9.5 Other Auxiliary Systems

The information in this section of the reference ABWR DCD, including all subsections, tables, and figures, as modified by the STP Nuclear Operating Company Application to Amend the Design Certification rule for the U.S. Advanced Boiling Water Reactor (ABWR), "ABWR STP Aircraft Impact Assessment (AIA) Amendment Revision 3," dated September 23, 2010 is incorporated by reference with the following departures and supplements.

STD DEP T1 3.4-1	STD DEP 9.5-2 (Figure 9.5-3, replaced entire figure)
STP DEP 1.1-2 (Figures 9.5-2, 9.5-4 and 9.5-5)	STD DEP 9.5-3
STP DEP 1.2-2 (Table 9.5-5)	STD DEP 9.5-4
STD DEP 8.3-1	STP DEP 9.5-6 (Figure 9.5-6)
STD DEP 9.4-2 (Table 9.5-5)	STP DEP 9.5-7 (Table 9.5-5)
STD DEP 9.5-1	STD DEP Admin

Figure 9.5-2 Outline - Telephonic Communication System for Single Unit of STP 3 or 4

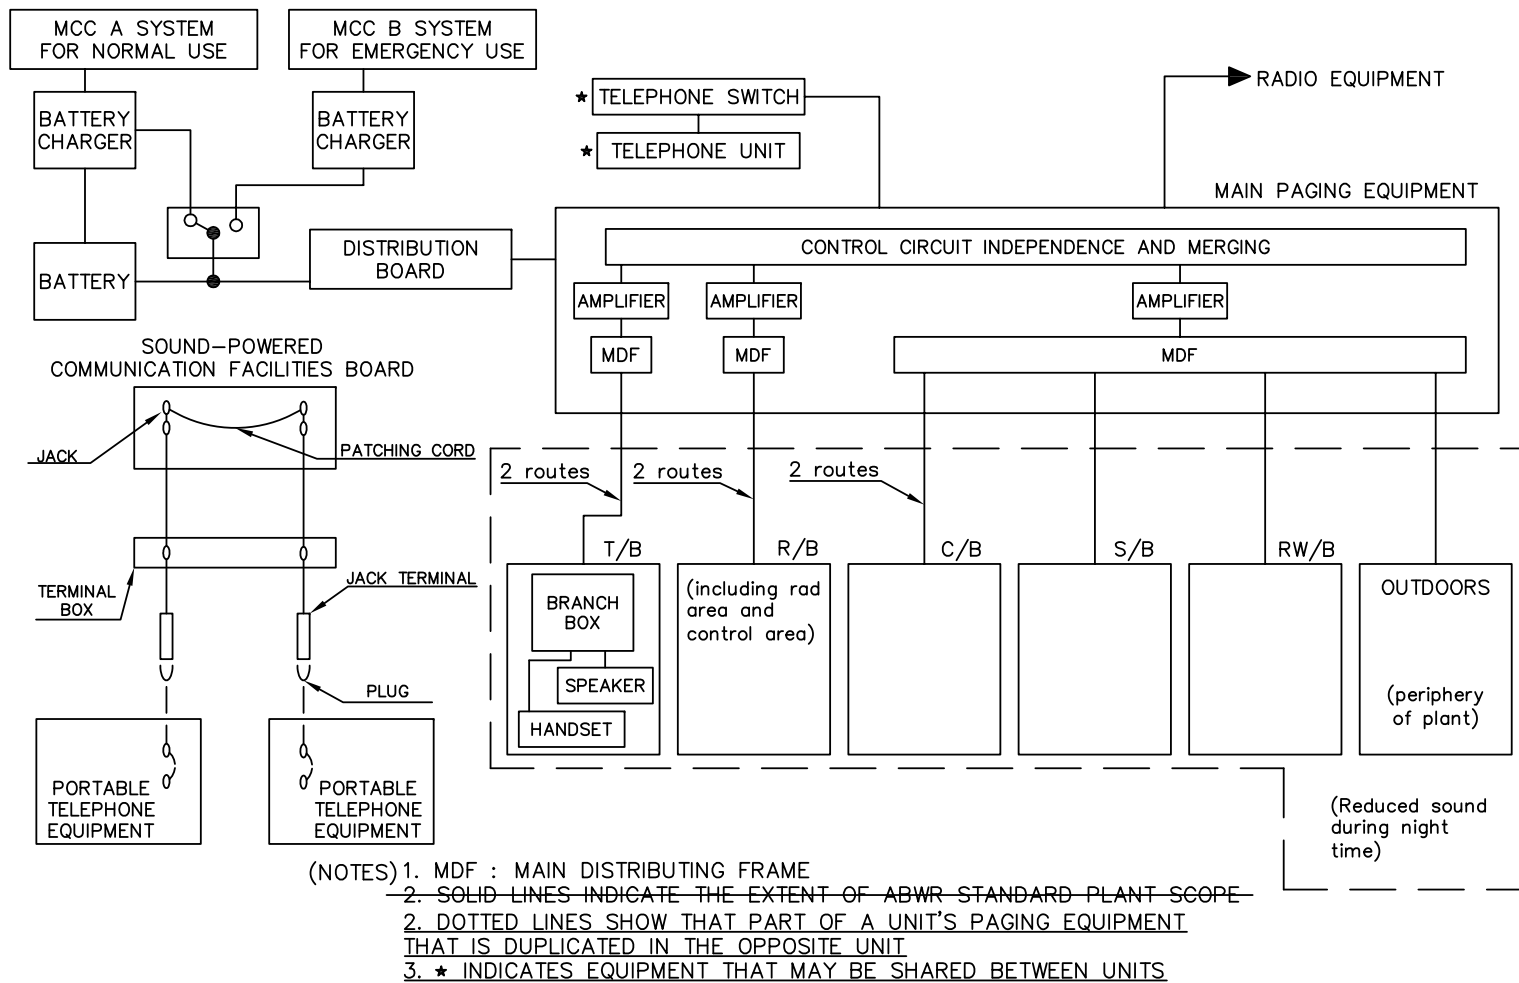
At STP 3 & 4, a common communication system is used to provide plant-wide communications between the dual units. The communication system is not safety-related. A common communication system providing plant wide communications is a safety enhancement since it allows for ease of communication between units. The representative outline of the common communication system is shown in Figure 9.5-2 for STP 3 & 4.

Figure 9.5-3 Lower Drywell Flooder System Arrangement/Configuration

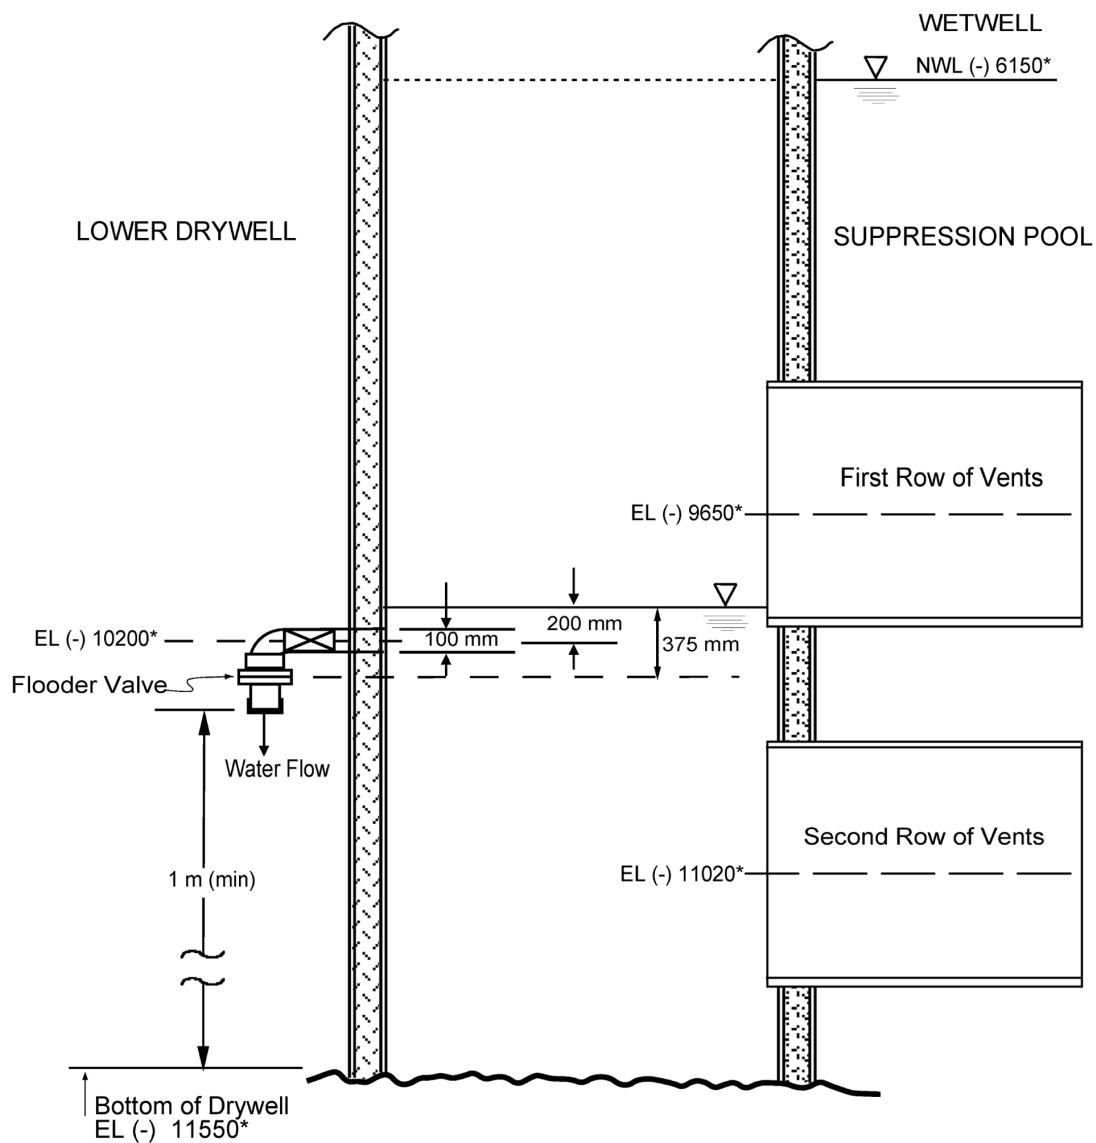
The LDF, shown schematically in Figure 9.5-3, provides a flow path for suppression pool water into the lower drywell area during severe accident scenario that leads to core meltdown, vessel failure, and deposition of molten corium on the lower drywell floor. Molten corium is a molten mixture of fuel, reactor internals, the vessel bottom head and control rod drive components. The flow path is opened when the lower drywell airspace temperature reaches 260°C.

The LDF consists of ten pipes that run from the vertical pedestal vents into the lower drywell. Each pipe ~~contains~~ has an isolation valve and a fusible plug valve connected to the end of the pipe that extends into the lower drywell ~~by a flange~~. The fusible plug valves open when the drywell air space ~~(and subsequently the fusible plug)~~ temperature reaches 260°C. When the fusible plug valves open, a minimum of 10.5 L/s of suppression pool water will be supplied through each floodor pipe (105 L/s total) to the lower drywell to quench the corium, flood the lower drywell and remove corium decay heat, which is estimated at 1% of rated thermal power. The flow rate is based on a minimum hydrostatic head of 200 mm above the floodor pipe inlet centerline and takes the frictional losses through the floodor pipe and fusible plug valve into account.
